**LYTLE CREEK (MUSCOY)
LEVEE SYSTEM
SAN BERNARDINO COUNTY, CALIFORNIA
NLD SYSTEM ID # 3805010071**

**PERIODIC INSPECTION REPORT NO 1
GENERALIZED EXECUTIVE SUMMARY**

**FINAL SYSTEM RATING: MINIMALLY ACCEPTABLE
FINAL RATING DATE: OCTOBER 17, 2013**

Figure 1: Lytle Creek (Muscoy) Levee System

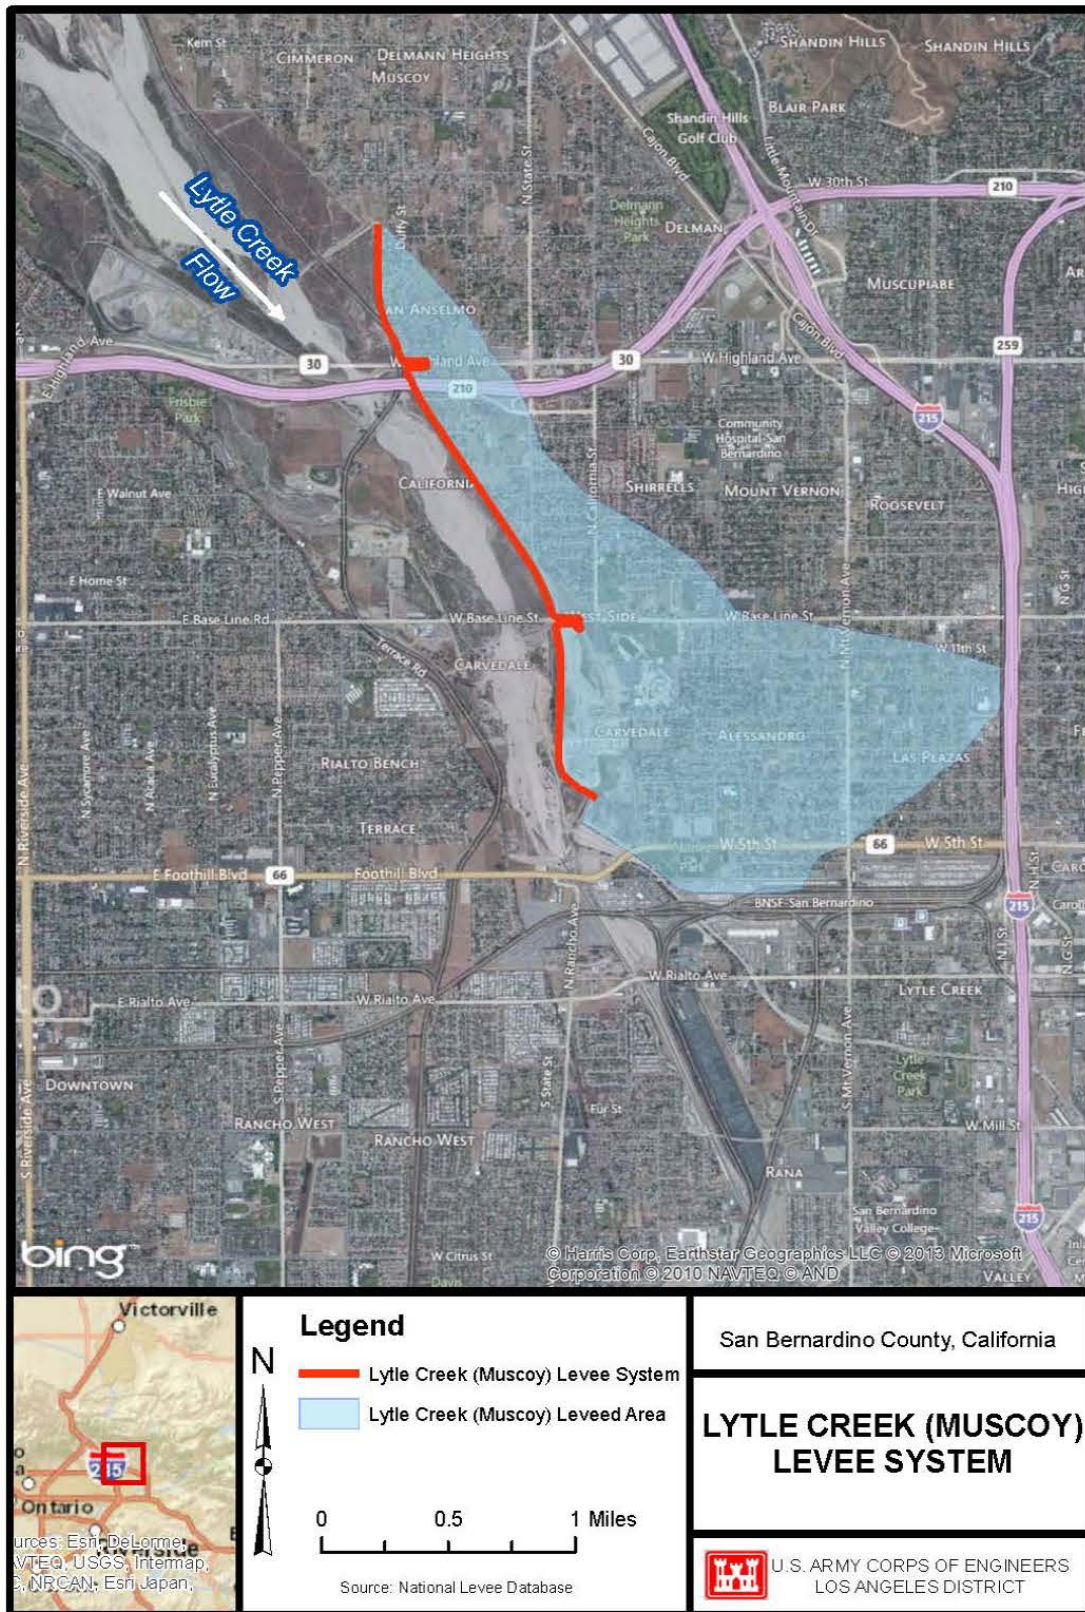
On June 13, 2013, the leveed area was revised per signature of the Levee Safety Officer and is shown on Figure 1. This leveed area supersedes the leveed area in the Periodic Inspection Report No. 1.
